Product Change Notice (PCN)

PCN Number: **PCN-0451100R-02**

Product(s) Affected: SJD1-3201-54

PREVIOUS CUI DEVICE'S DETAIL / IMAGE	NEW CUI DEVICE'S DETAIL / IMAGE

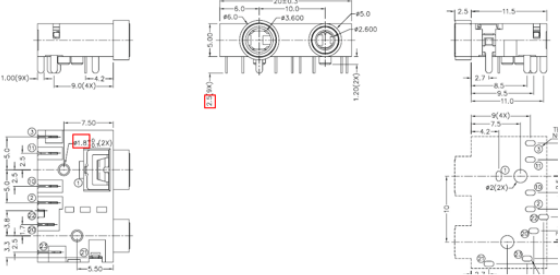
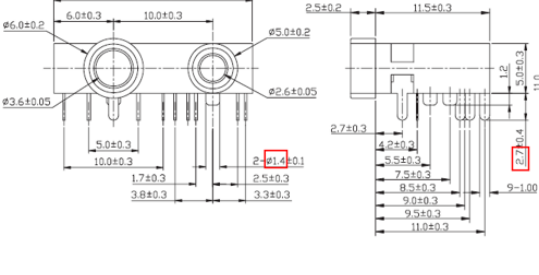
Description of Change: mechanical and material differences as shown below:

MATERIAL	PLATING
terminal 1	copper alloy	tin
terminal 2	copper alloy	tin
terminal 3	copper alloy	tin
terminal 10	brass	tin
terminal 11	brass	tin
terminal 20	brass	tin
terminal 21	copper alloy	tin
terminal 22	copper alloy	tin
terminal 23	copper alloy	tin
bushing	brass	nickel
plastic	PBT

DESCRIPTION	MATERIAL	PLATING/COLOR
terminal 1	copper alloy	tin
terminal 2	stainless steel t=0.20	tin
terminal 3	stainless steel t=0.20	tin
terminal 10	brass t=0.40	tin
terminal 11	brass t=0.40	tin
terminal 20	brass t=0.40	tin
terminal 21	phosphor bronze t=0.30	tin
terminal 22	stainless steel t=0.20	tin
terminal 23	phosphor bronze t=0.25	tin
bushing	copper alloy	nickel
housing	PAB6+GF15% (UL94HB)	black
